**KINGS RIVER CONSERVATION DISTRICT PEAKING PLANT  
DATA REQUEST RESPONSES**

Technical Area: Air Quality

**Construction Impacts Modeling  
Background**

**ATTACHMENT  
GEOLOGY DR-21**

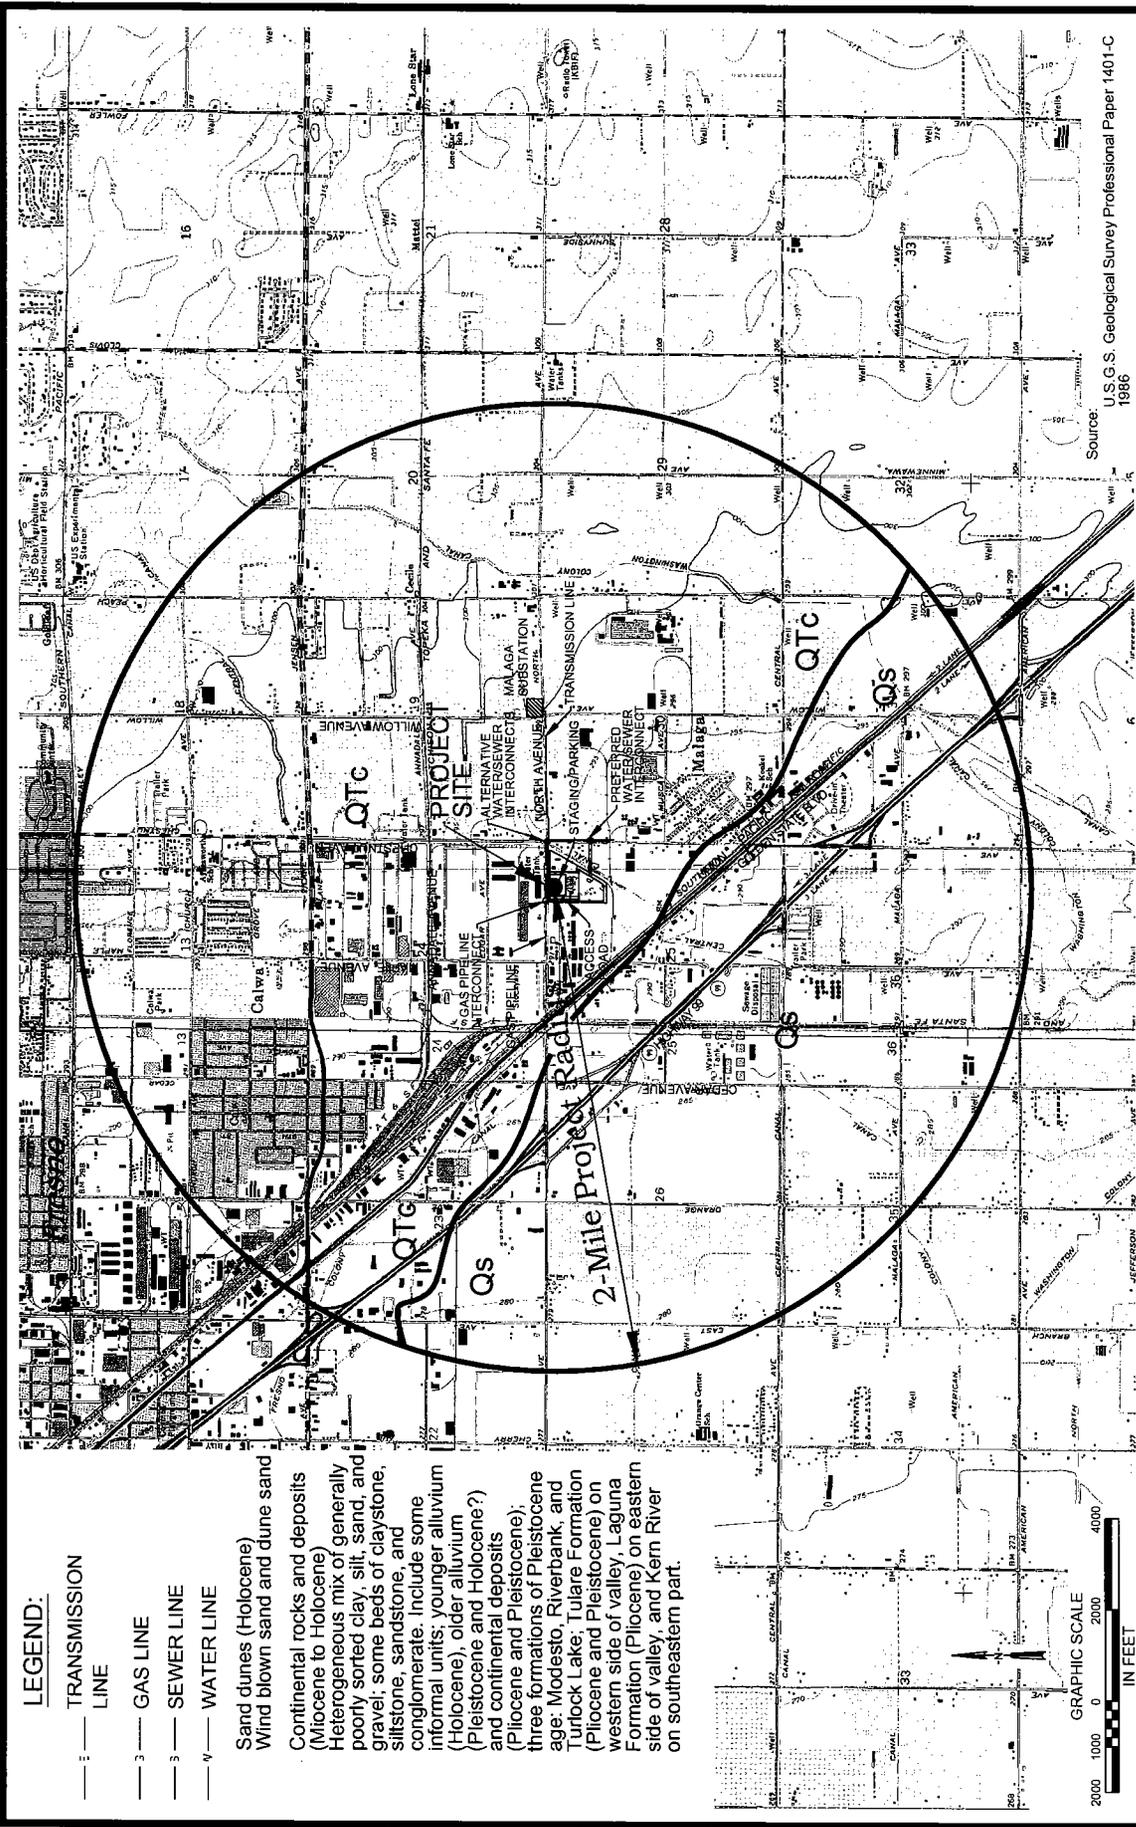
No legend for fault types is shown on Figure 5.11-2.

21. Please provide a complete legend including fault types for Figure 5.11-2.

The Central Valley Thrust Fault System is not shown on Figure 5.11-2 or described in the text.

A legend describing the symbols used for the faults has been added to Figure 5.11-2 from the KRCDPP SPPE. A revised version of Figure 5.11-2 is included as Attachment Geology DR-21.

Figure 5.11-2 (Attachment Geology DR-21) has been modified to include the Central Valley (Great Valley) Thrust Fault System. The Great Valley Thrust Fault System consists of a series blind thrust faults with the shallowest depth occurring about 7 kilometers below the surface (U.S. Geological Survey Open File Report 96-705, Database of Potential Sources for Earthquakes Larger than Magnitude 6 in Northern California). The fault system has been detected through geophysical surveys and is located based on truncated dipping beds and earthquake activity. The fault system trends northwest-southeast and dips to the west, away from the KRCDPP facilities. The most recent seismic activity on the Great Valley Thrust Fault System, in the vicinity of the KRCDPP, was the 1983 Coalinga earthquake, which registered a 6.7 magnitude on the Richter Scale. There were no apparent surface features or ground ruptures to indicate the presence of this fault (Mualchin, 1996).

**ATTACHMENT  
TRANSMISSION DR-33&34**

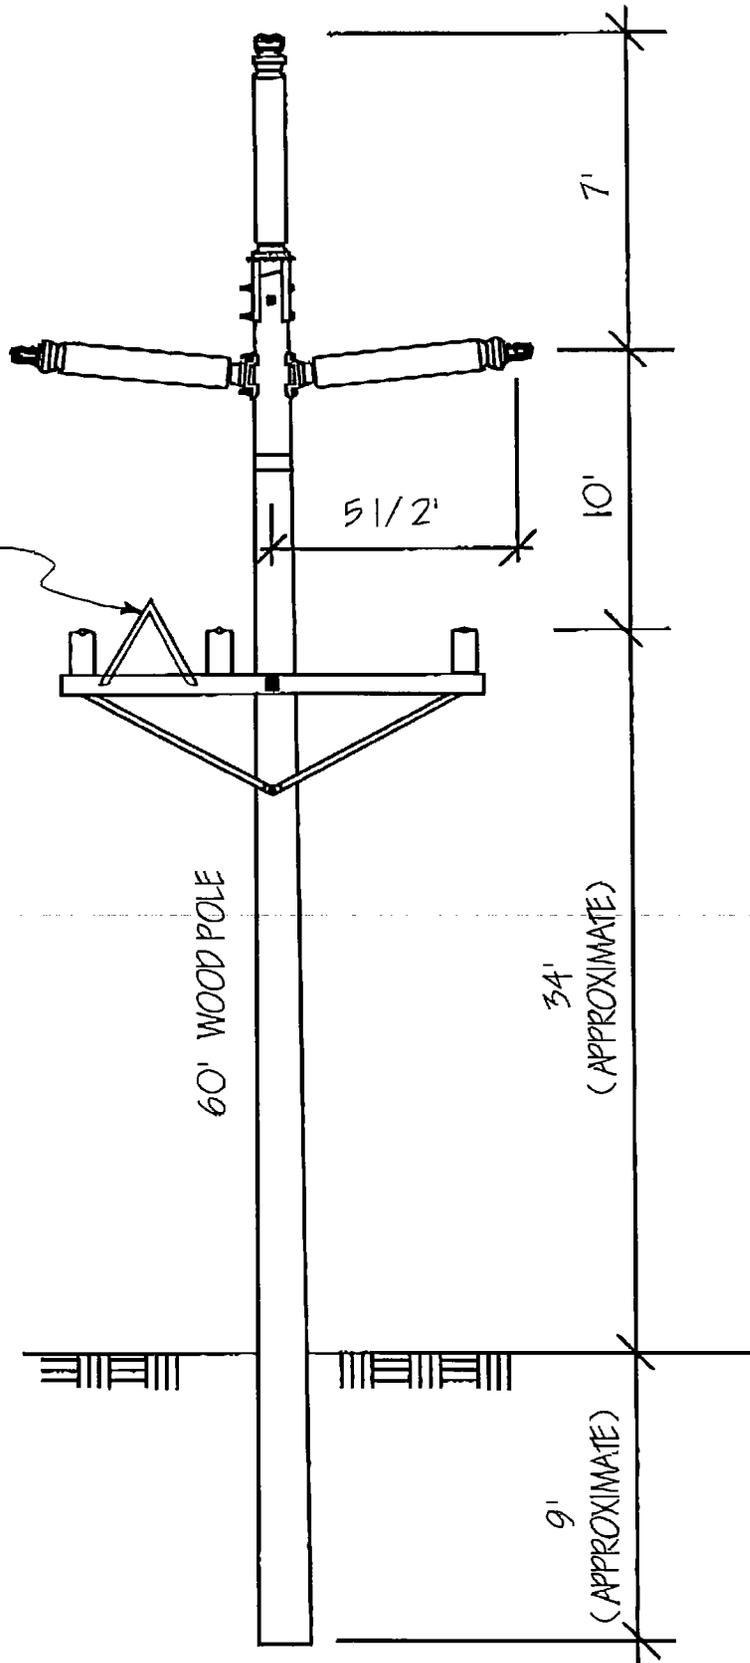
33. Provide Power flow diagrams (MW, percent loading & P. U. Voltage) for n-2 contingency studies where post project overload criteria violations have occurred.
34. Provide electronic copies of the PSLF \*.sav & \*.drw files of all base cases, and EPCL and/or AUTOCON contingency and comparison files. Provide electronic copies of the PSLF \*.dyd and \*.swt dynamic data files for 2005 summer off-peak base case.
35. Resubmit Figure 2.8-1 (refer to the Application for SPPE, Section 2.8.1, Page 12) with necessary dimensions and clearances.
36. Provide a one-line Diagram(s) of the new 115 kV interconnecting overhead line with specifics and details about the mileage, route and termination facilities (Breaker and/or Line switches) at the project end and Malaga Substation. Also clarify who will design, build, own and operate the project switchyard and the new 115 kV interconnection line.

Five electronic copies (on compact disk) of Attachment Transmission DR-33&34 have been provided.

**ATTACHMENT  
TRANSMISSION DR-36**

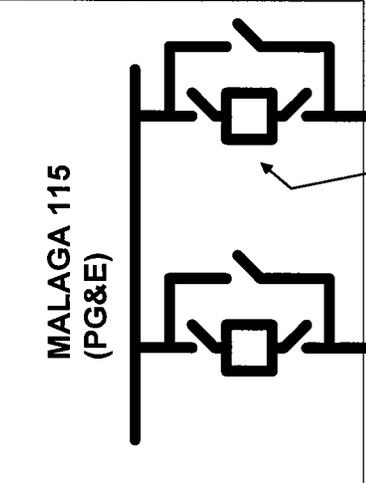
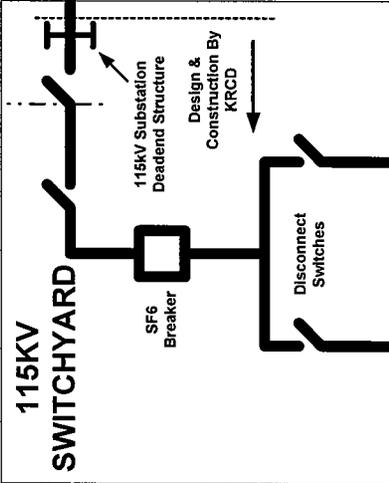
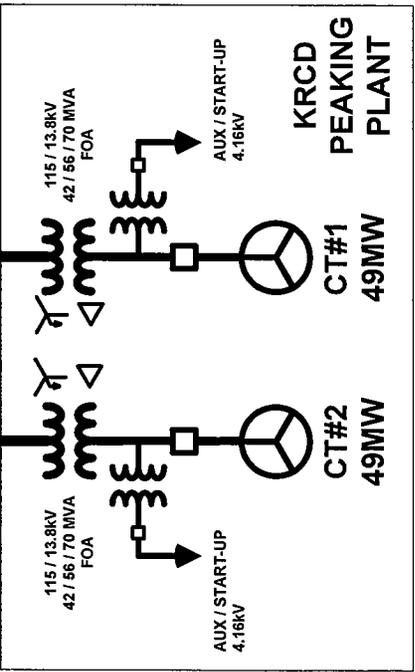
- Power Flow diagrams were not provided for n-2 contingency studies when post project overload criteria violations have occurred.
- There is no one-line diagram regarding the description of the new 115 kV generator tie line showing the route, and the length of the line has been identified as three-quarters of a mile compared to a half mile as mentioned in the PG&E SIS report (Refer to Chapter 2, Section 2.8.1, Page 12 and Appendix 2.8.1, SIS report, Figure 2-1, Page 2). An existing 115 kV line (Ranchers Cotton Tap) is also shown near the proposed route along North Ave between Chestnut Ave and Willow Ave in Figure 2-2 of the SIS report (SIS report, Page 3).

- The single line diagram, Figure 3.11-1, in the Application shows a motor operated 1200 Ampere Line disconnect Switch at the project switchyard for the new 115 kV interconnection line to Malaga Substation. But in the SIS report prepared by PG&E (Refer to Appendix 2.8.1, SIS report, Section 8.3, Pages 11 & 12) it was stated that “The 115 kV breaker to be installed on the Malaga 115 kV bus and at the Kings River Conservation District Peaking Project facility must have two (2) sets of current transformers for each bushing.”
